TECHNICAL BULLETIN

For Auger Unloading Collars: A-71333439 and A-71339770

Figure 2 L, S/N 26001-
M, S/N 24701-

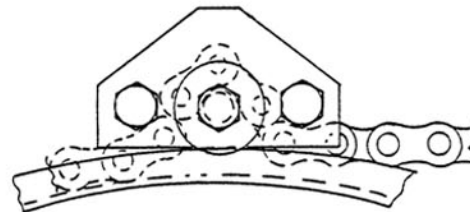
Chain is threaded through a set of bolts which tighten chain. Same as Auger Unloading Collar received.
